SUBJECT: SERVICE BULLETIN S07LZ PDU CLOSEOUT FASTENERS

AFFECTED: 2004-08 MODEL YEAR VISION (BBCV) BUSES

PDU Closeout Fasteners

MODELS AFFECTED: Certain 2004-2008 BBCV Visions

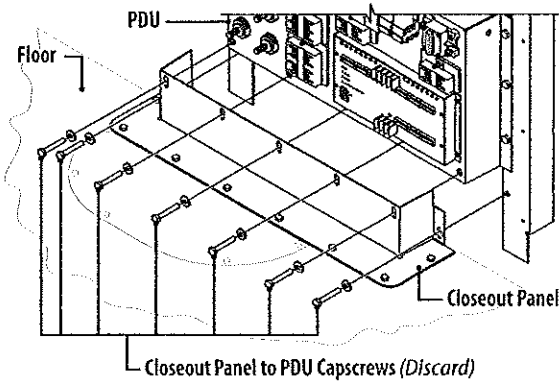
The fasteners used to attach the closeout panel to the Power Distribution Unit (PDU) may not be the correct length.

Remove the incorrect length fasteners and replace with the correct length fasteners.

- 1 Park vehicle on a level surface, apply parking brake, turn engine off, and remove ignition key.
- 2 Loosen two thumb screws and remove the PDU cover.
- 3 Remove and discard seven Closeout Panel to PDU capscrews.

- 4 Install seven new capscrews (0000610) with washers (2127173) provided for the Closeout Panel to the PDU.
- 5 Reinstall the PDU cover.
- 6 Return the bus to service.
